UNITED STATES PATENT AND TRADEMARK OFFICE

APPLICATION NO.	FILING DATE	FIRST NAMED INVENTOR	ATTORNEY DOCKET NO.	CONFIRMATION NO.
10/560,521	12/13/2005	Steven G. Smarsh	Tru Tech P-305	6370

Office Action Summary	Application No. 10/560,521	Applicant(s) SMARSH, STEVEN G.	
	Examiner Shantese L. McDonald	Art Unit 3723

DETAILED ACTION

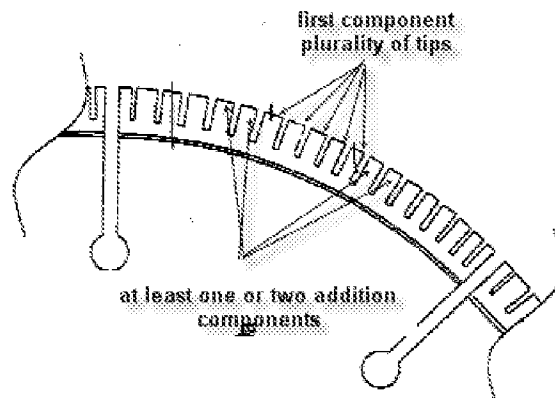
Liao teaches a dressing wheel component including an interrupted cutting outer surface wherein the interrupted surface, 200a, is embodied in a cutting wheel, 20, with a plurality of flat tips, 200, extending outwardly from the outer surface. Liao teaches that the grinding wheel further comprises additional dressing wheel components, which are flat grinding surfaces, adjacent to and surrounding the interrupted cutting outer surface. (The examiner notes that each flat tip, 200, is considered to be a dressing wheel component that is adjacent to and surrounding the interrupted cutting outer surfaces, 200a). Liao also teaches that the flat grinding surfaces comprise diamonds, 30. Liao teaches all the limitations of the claims except for the cutting outer surface being selected from the group consisting of stainless steel of any grade, cold rolled steel, brass and combinations thereof. Liao teaches that prior art cutting wheel can be made from materials such as bronze or steel or other metals. It would have been obvious to one having ordinary skill in the art at the time the invention was made to make the tool of Liao from the group consisting of stainless steel of any grade, cold rolled steel, brass

The Applicant argues about the inconsistencies of the comparison of the components of Liao with the present invention. The Examiner disagrees, and has included the labeled figure below to show the comparison and interpretation of Liao as applied to the present claimed limitations.
